Technical Service Bulletin

19 Coolant warning light or coolant loss - R8 4.2 FSI

19 13 37 2026109/2 May 13, 2013. Supersedes Technical Service Bulletin Group 19 number 11-23 dated April 14, 2011 for reasons listed below.

Figure 1. Splash guard aligned with fan control unit.

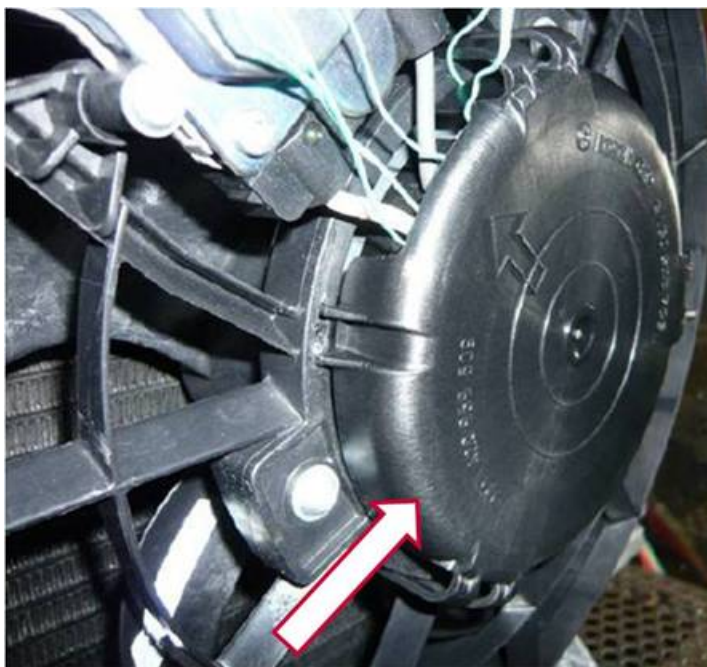
The left and/or right side radiator cooling fans may be inoperative due to corrosion caused by water ingress into the fan motors or into the fan control units. As a result, coolant temperatures may exceed the permissible value, leading to increased system pressure and potential coolant loss from the system. Indication of coolant loss may be noticed coming from the coolant reservoir.

A splash guard was installed on the cooling fan to protect the fan motor and the fan control unit (Figure 1).

1. Remove the front vehicle underbody cover. Refer to *Body Exterior >>Rep. Gr.66>>Removal and Installation*.
2. Check the both fans for stiffness or rough running. If necessary, replace one or both auxiliary cooling fans (if applicable).
3. Install the two splash guards.

Tip: The splash guard must be fitted with the arrow on the splash guard aligned with fan control unit.
